**A66 Northern Trans-Pennine project
TR010062**

**8.1 Change Application –
Application Report**

24 March 2023

Planning Inspectorate Scheme Reference	TR010062
Application Document Reference	8.1
Author:	A66 Northern Trans-Pennine project, Project Team, National Highways

Figure DC-11(b) Extract from General Arrangement Drawing (After)

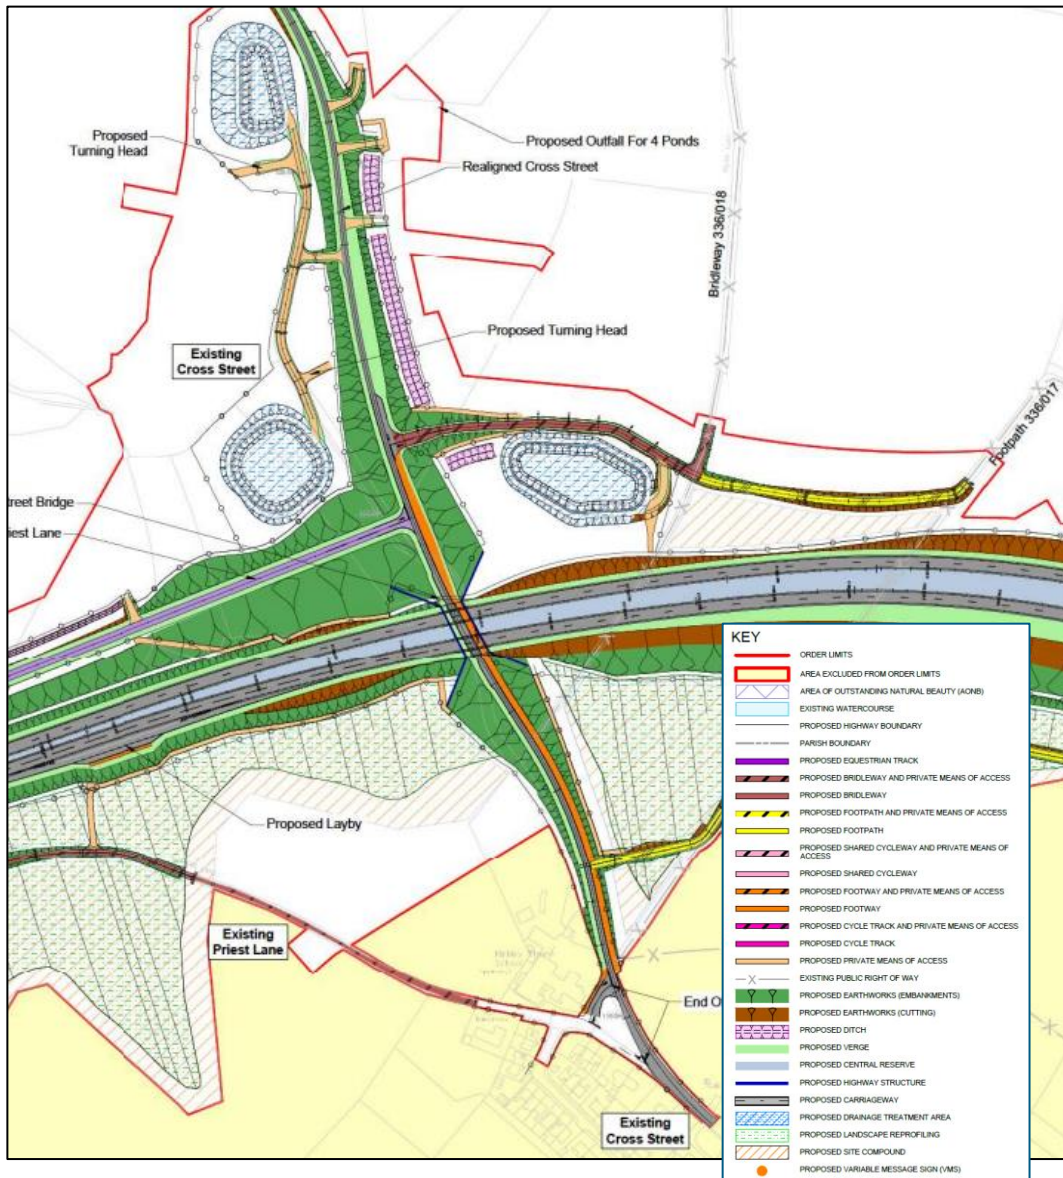
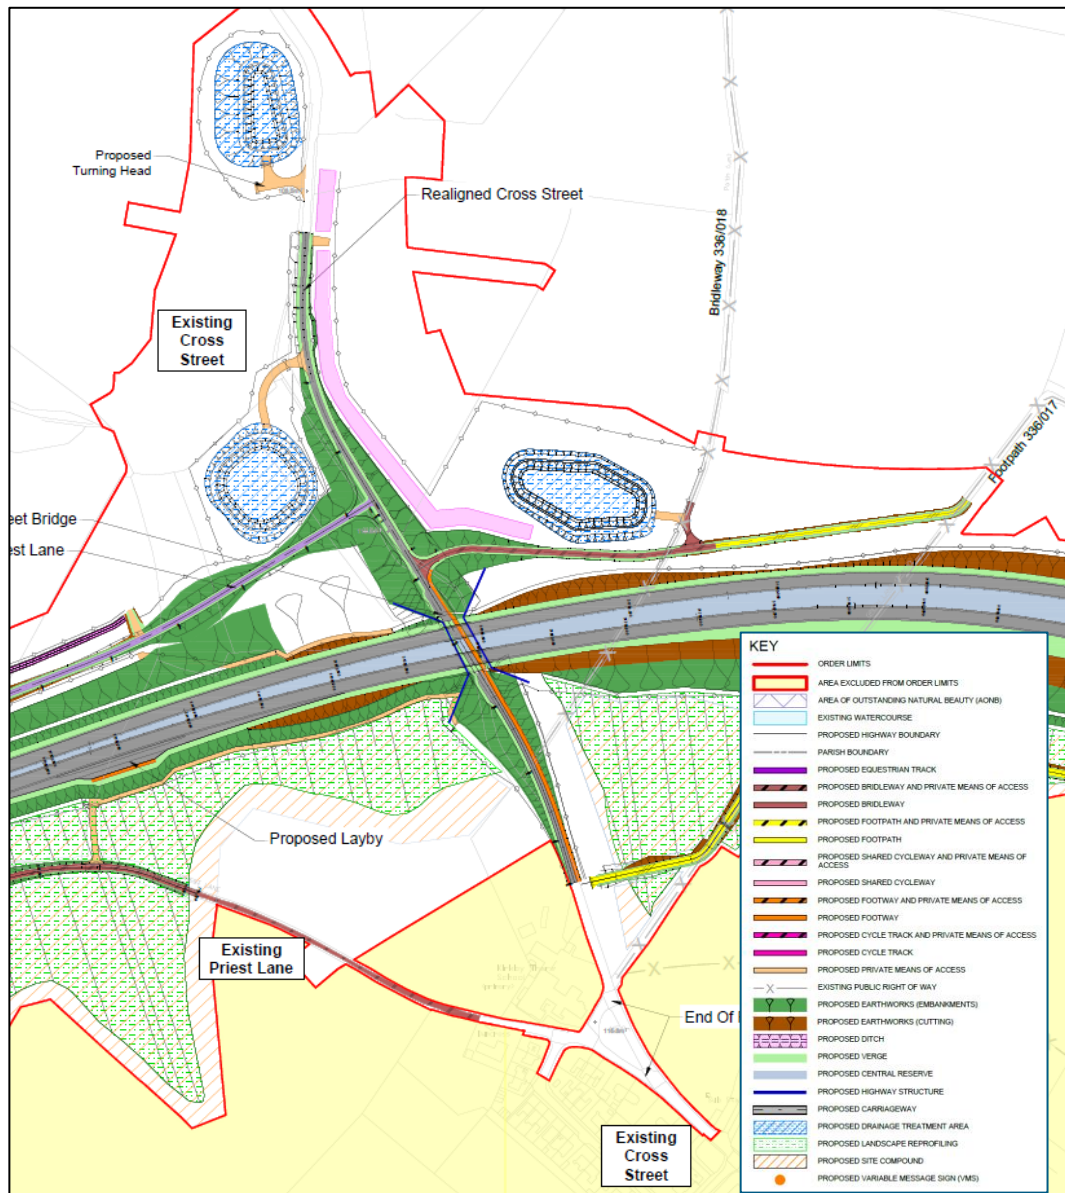
3.11.1. **Background to the change:** The re-aligned Cross Street shown in the DCO application documents is for a 60mph rural road to current DMRB design standards for the horizontal and vertical geometry. Based on a realistic worst case design principle the road alignment was extended northwards to ensure a suitable transition of comparable geometrical standards could be achieved. This removed the existing below standard bends of Cross Street, particularly to the north of the A66 mainline.

above existing ground, while keeping the same road width of 3.5m (with passing places) as proposed in the current DCO design.

Figure DC-11(c) Before (left) & After (right) Extracts from Traffic Regulation Measures (Speed Limits) Plans

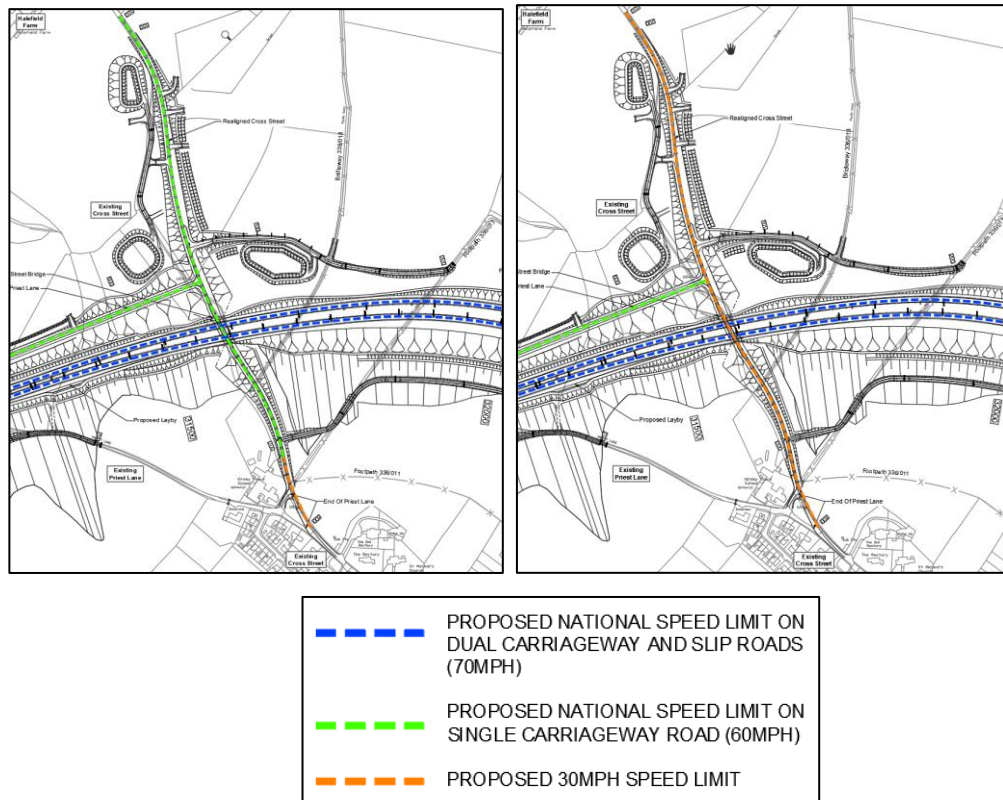
3.11.3. Alignment/ Design Speed/ Speed Limit: To achieve this change, parts of the diverted Priest Lane and diverted bridleway 336/018 are also realigned to tie-in to the realigned Cross Street. The design speed of Cross Street is reduced to allow for the road geometry to be changed while maintaining compliance with local highway design standards. To ensure the change is safe for all road users, a reduction in the speed limit to 30mph is required for the full length of the re-aligned Cross Street (from the existing 60mph speed limit, which is currently proposed in the DCO application). This will in effect extend the current 30mph zone outwards from the village.

Figure DC-11(e) Extract from Works Plan (After)

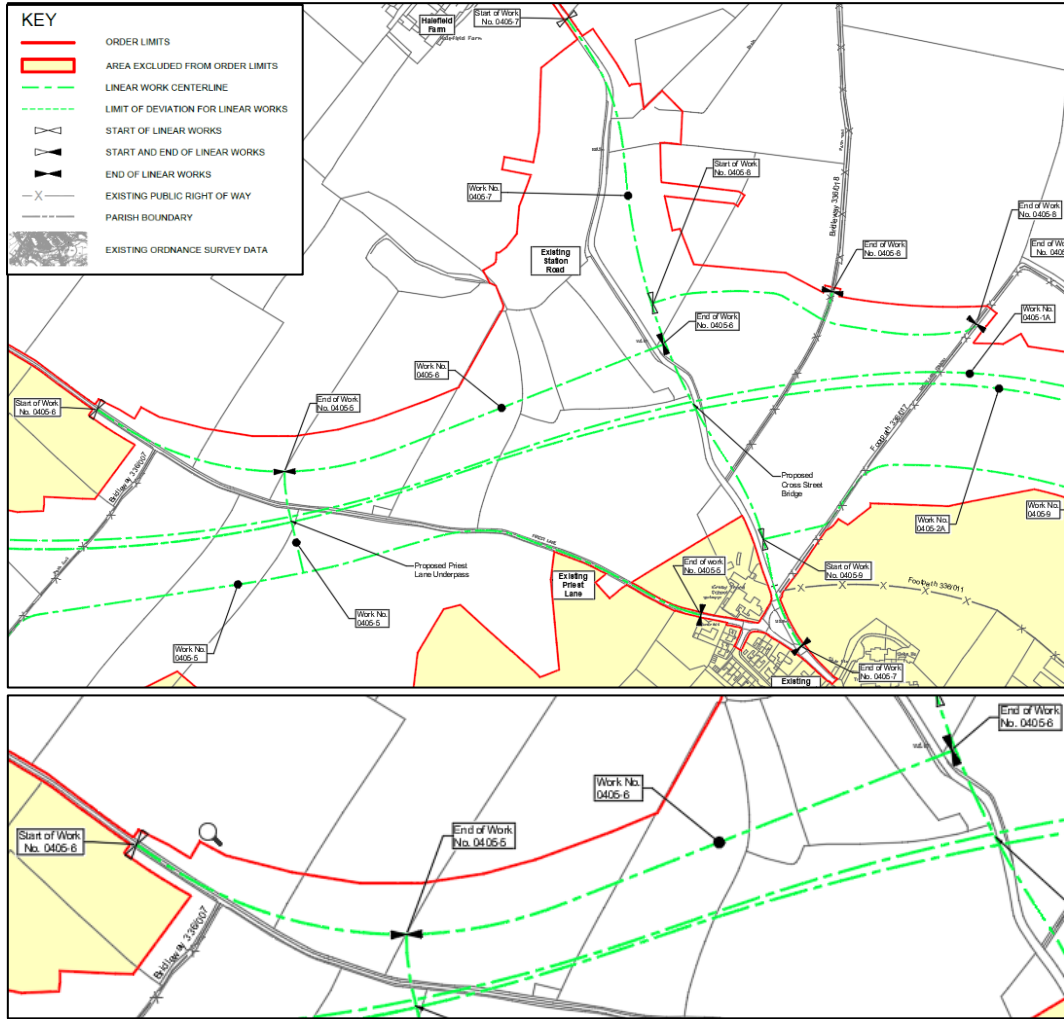
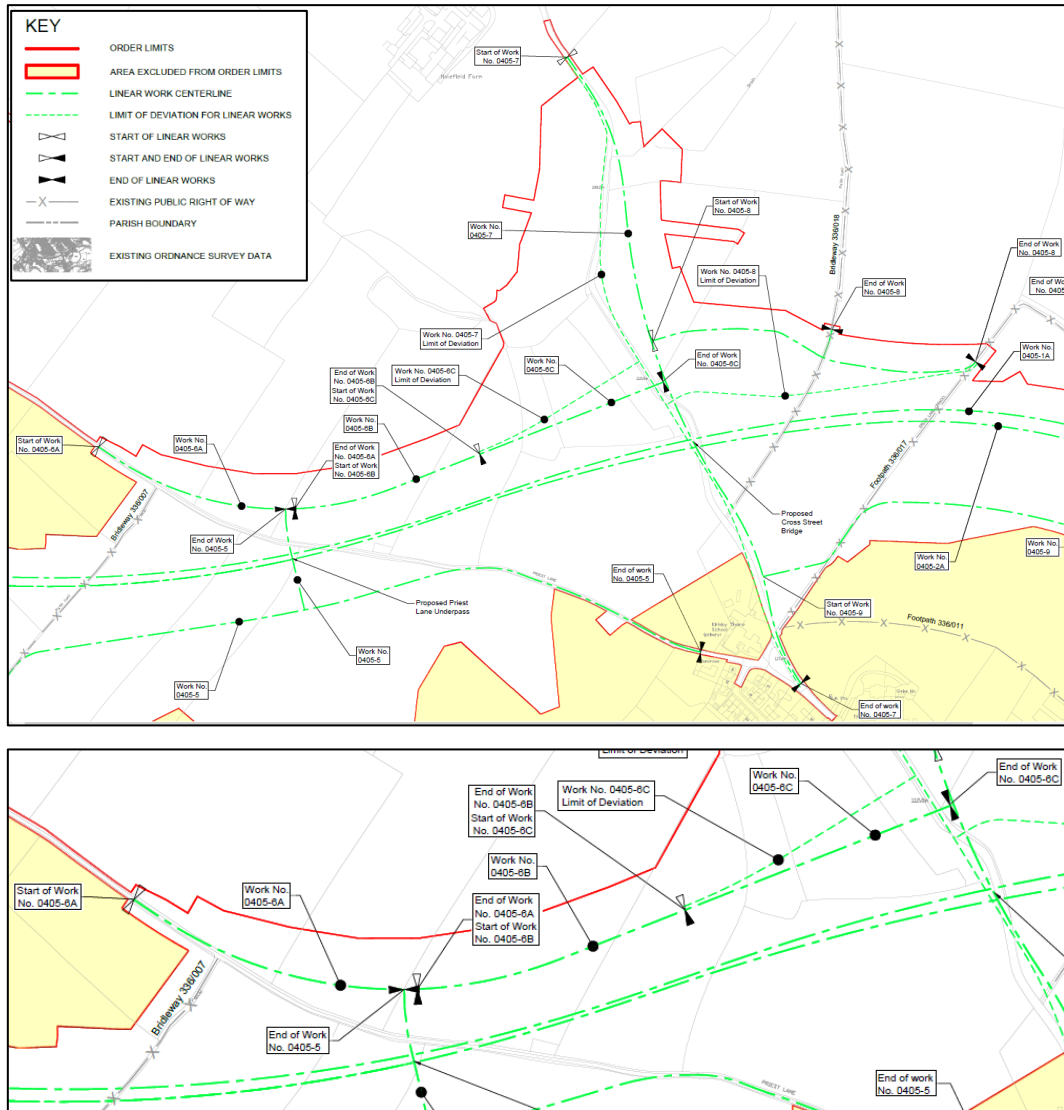
- 3.11.13. As outlined in Table DC-11(a), Work No. 0405-6 is to be split in to three parts to facilitate changes to Priest Lane to enable it tie-in to Cross Street. This will create Work No. 0405-6A, Work No. 0405-6B (at Ch0+250m) and 0405-6C (at Ch0+480m). The split Work No. 0405-6 is shown in Figure DC-11(e).

Figure DC-13(b) Extract from General Arrangement Drawing (After)

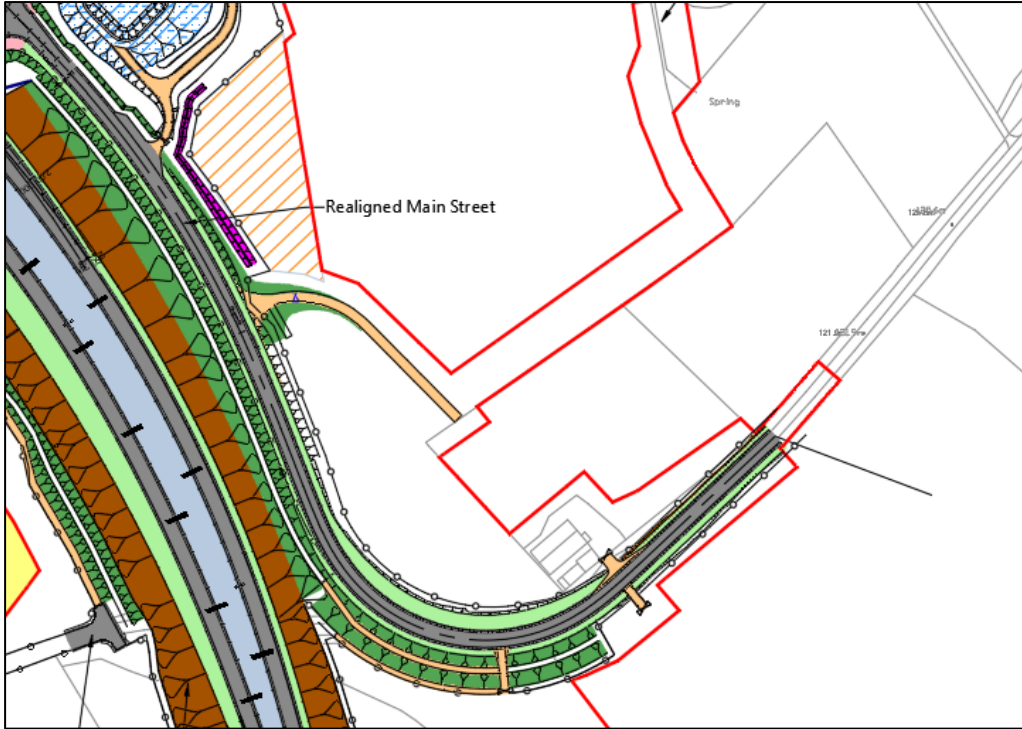
- 3.13.2. **Description of the change:** To the north-east of Kirkby Thore, the change seeks to provide greater flexibility in the LoDs to allow for changes to the alignment of the diverted Main Street to reduce the impact on local business and make it more in keeping with the local rural road network.
- 3.13.3. The Proposed Change would also remove an access track to fields to the north-east of Main Street with access not being provided directly from the diverted Main Street, as the levels of the road are closer to existing ground levels than in the DCO design.

Figure DC-13(e) Extract from Works Plan (After)

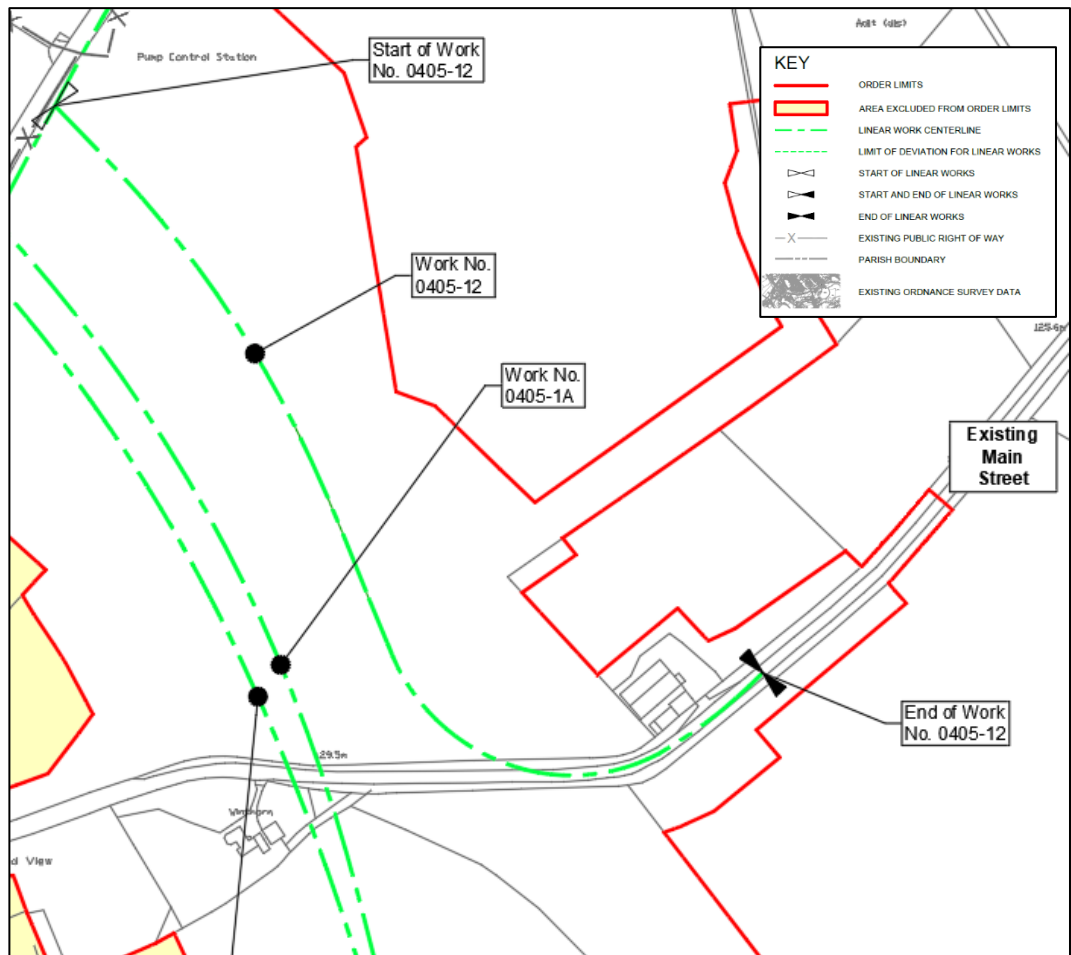
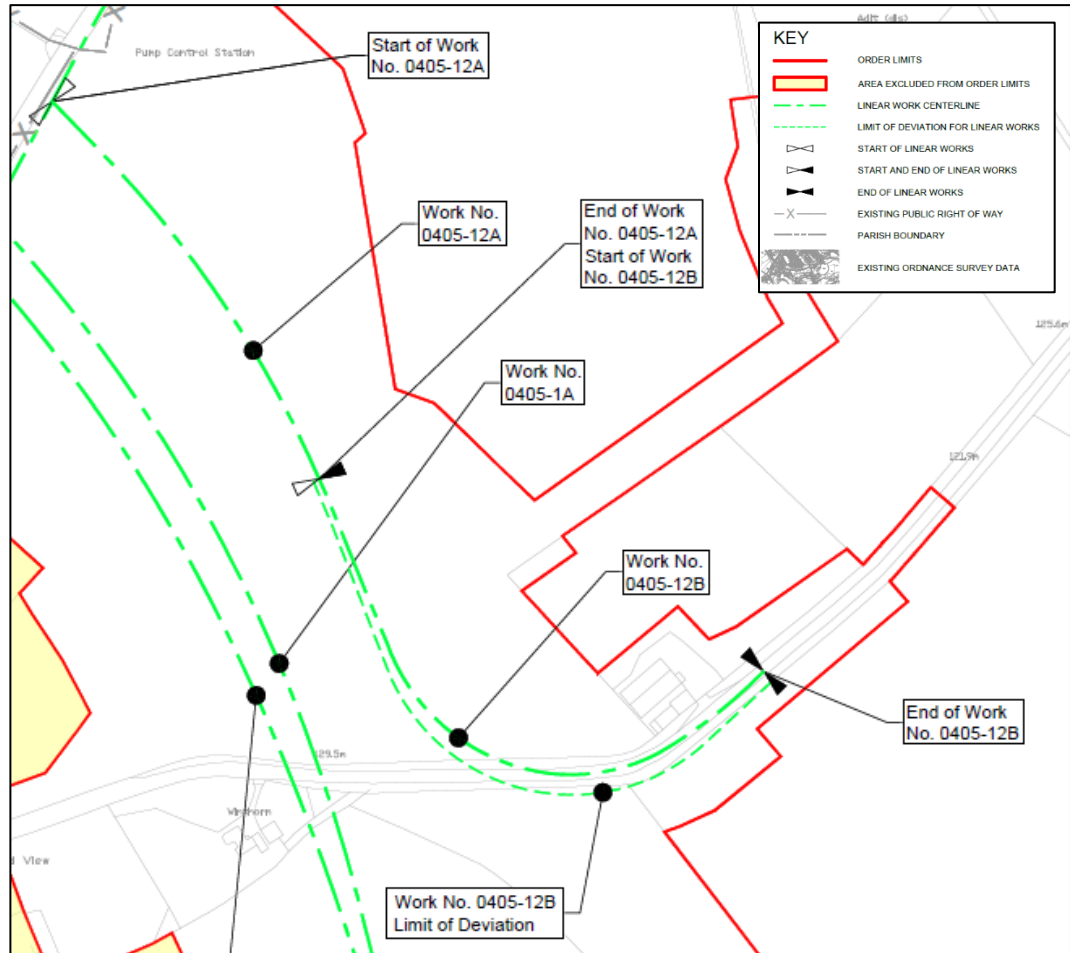
- 3.13.14. As outlined in Table DC-13(a), Work No. 0405-12 is to be split in to two parts to facilitate changes to Main Street. This will create Work No. 0405-12A and Work No. 0405-12B (at Ch0+210m). The split Work No. 0405-12 is shown in Figure DC-13(e).

Figure DC-14(b) Extract from General Arrangement Drawing (After)

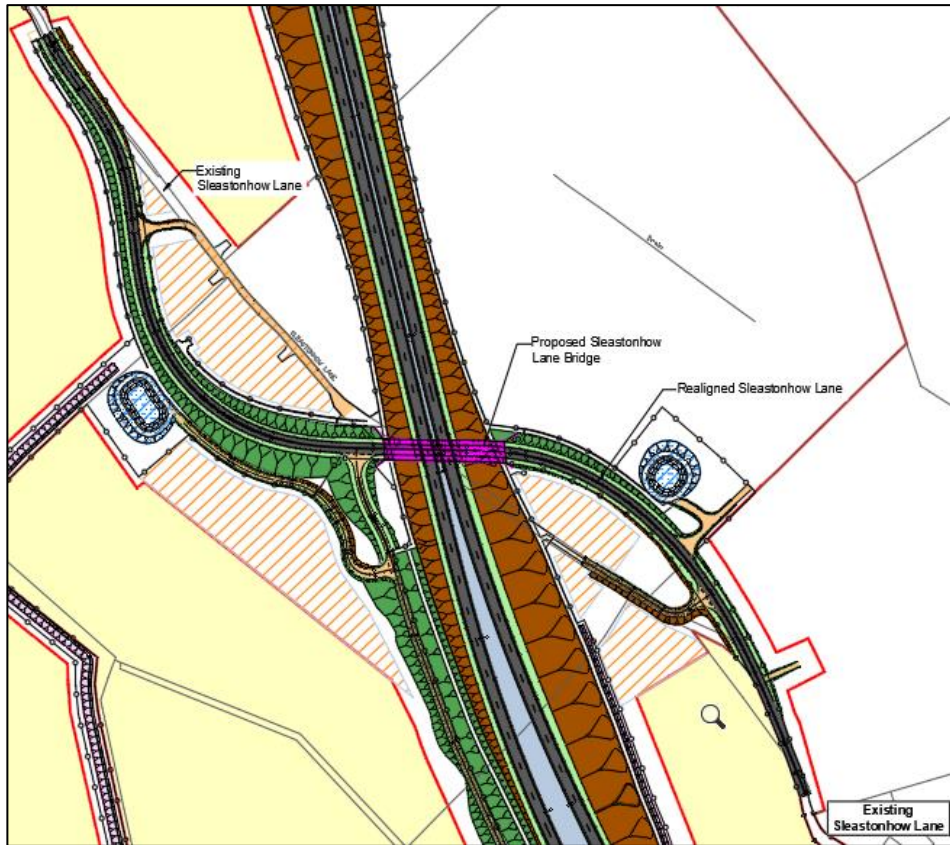
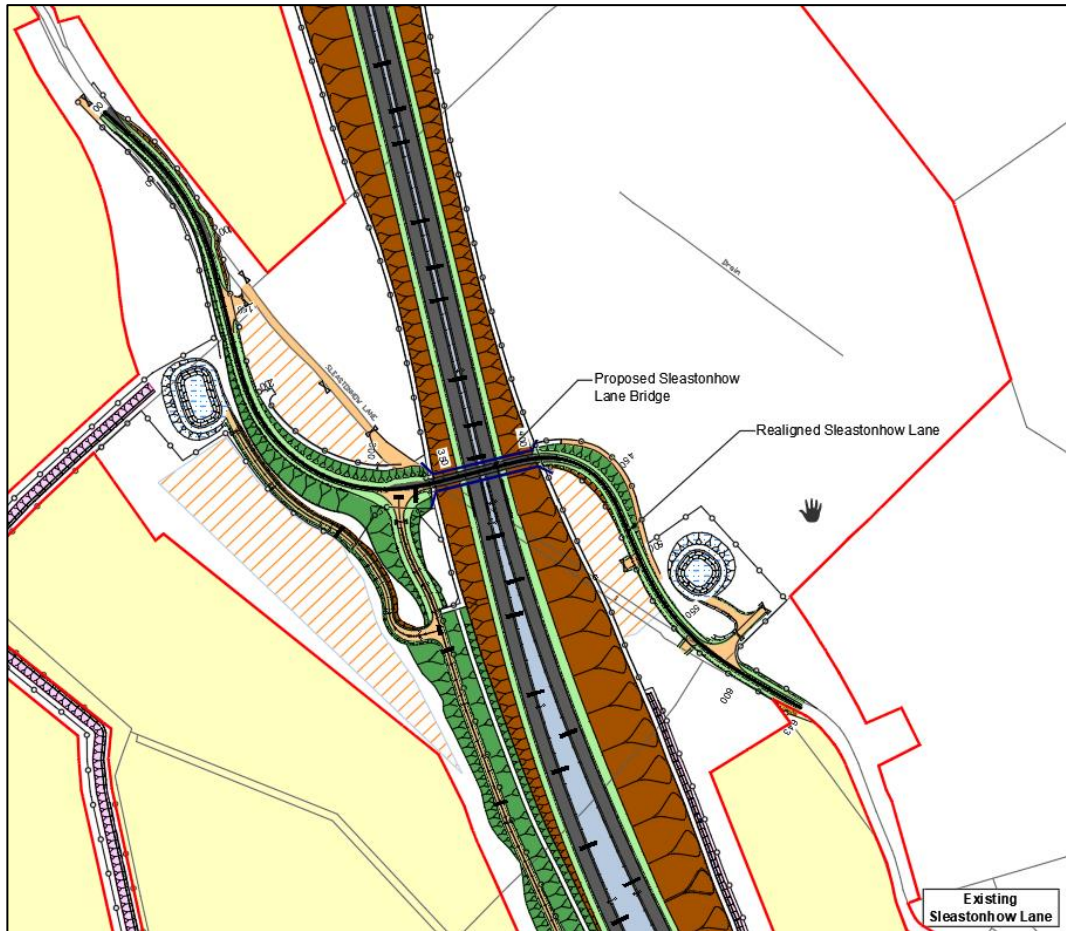
- 3.14.1. **Background to the change:** The re-aligned Sleastonhow Lane shown in the DCO application documents is for a 60mph rural road to current DMRB design standards for the horizontal and vertical geometry. To avoid tying into the existing below standard existing bends the alignment was extended to ensure a suitable transition of comparable geometrical standards could be achieved based on a realistic worst case design principle.

- 3.14.2. **Description of the change:** The proposed change seeks to provide greater flexibility in the LoDs to allow for changes to the alignment of Sleastonhow Lane so that it is more in keeping with the local rural road network. Where the lane crosses the proposed A66 mainline a crossing at a near right angle would create two sharper bends either side of the proposed dual carriageway reducing the length of carriageway required while avoiding the veteran trees. Intervisible passing bays would be included either side of the structure to allow vehicles to wait.
